Access Compliance Report

Public Rights-of-Way

(Pedestrian Signals)

Intersection ID: N/A	Main Street:	Cross Street: N/A	Location: N/A
ADA ID: 6675BCDEDA23	Signal Type: One Push Button-Non APS	Overall Compliance: No	Severity Score: BTN 1: N/A BTN 2: N/A No BTN: N/A
Codes/Mitigation Info/Possible Solution		Field Measurements/Component Compliance

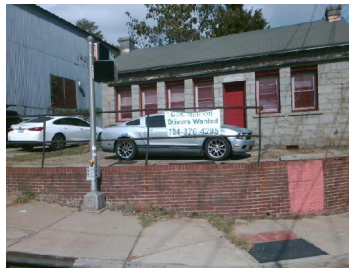
Compliance	Description	Data	Compliance	Description	Data
	Button Count	Button1	N/A	Distant to Additional Button (in)	N/A
	Additional Button Present?	No		Additional Button ID	N/A
N/A	Signal Buttons Required?	N/A	N/A	Additional Ped Posts Required	N/A
	How Many Ped Street Xings?	2		Located In An Island/Median?	No
N/A	B 1 Sign Present?	Yes	N/A	B 2 Sign Present?	N/A
Yes	B 1 Sign Purpose?	Yes	N/A	B 2 Sign Purpose?	N/A
Yes	B 1 Sign Lettering & Contrast?	Yes	N/A	B 2 Sign Lettering & Contrast?	N/A
Yes	B 1 Parallel To XWalk?	Yes	N/A	B 2 Parallel To XWalk?	N/A
Yes	B 1 PAR to Button?	Yes	N/A	B 2 PAR to Button?	N/A
Yes	B 1 PAR to XWalk?	Yes	N/A	B 2 PAR to XWalk?	N/A
Yes	B 1 Clear Floor Space?	Yes	N/A	B 2 Clear Floor Space?	N/A
N/A	B 1 FWD Approach?	Yes	N/A	B 2 FWD Approach?	N/A
N/A	B 1 FWD Approach Constrained?	No	N/A	B 2 FWD Approach Constrained?	N/A
Yes	B 1 FWD Approach Reach (in)	0.0	N/A	B 2 FWD Approach Reach (in)	N/A

N/A	B 1 FWD Approach Width (in)	N/A	N/A	B 2 FWD Approach Width (in)	N/A
N/A	B 1 FWD Approach Obstruction?	No	N/A	B 2 FWD Approach Obstruction?	N/A
N/A	B 1 FWD Approach Obstruction Dist (in)	N/A	N/A	B 2 FWD Approach ObstructionDist (in)	N/A
N/A	B 1 PARA Approach?	Yes	N/A	B 2 PARA Approach?	N/A
N/A	B 1 PARA Approach Constrained?	No	N/A	B 2 PARA Approach Constrained?	N/A
Yes	B 1 PARA Approach Reach (in)	0.0	N/A	B 2 PARA Approach Reach (in)	N/A
N/A	B 1 PARA Approach Width (in)	N/A	N/A	B 2 PARA Approach Width (in)	N/A
N/A	B 1 PARA Approach Obstruction?	No	N/A	B 2 PARA Approach Obstruction?	N/A
N/A	B 1 PARA Approach Obstruction Dist (in)	N/A	N/A	B 2 PARA Approach ObstructionDist (in)	N/A
No	B 1 Clear Floor Space Slope (%)	11.0	N/A	B 2 Clear Floor Space Slope (%)	N/A
No	B 1 Clear Floor Space XSlope (%)	3.0	N/A	B 2 Clear Floor Space XSlope (%)	N/A
N/A	B 1 PAR Slope (%)	10.6	N/A	B 2 PAR Slope (%)	N/A
Yes	B 1 Height (in)	37.0	N/A	B 2 Height (in)	N/A

N/A	B 1 Clear Xing Direction?	N/A	N/A	B 2 Clear Xing Direction?	N/A
	B 1 Crossing Direction	To E		B 2 Crossing Direction	N/A
No	B 1 DistanceTo XWalk (in)	97.0	N/A	B 2 DistanceTo XWalk (in)	N/A
No	B 1 DistanceTo Curb (in)	82.0	N/A	B 2 DistanceTo Curb (in)	N/A
Yes	B 1 Diameter (in)	2.0	N/A	B 2 Diameter (in)	N/A

Possible Solutions: Replace Signal Push Button With APS Button on New Post. Remove & Relocate Sign.
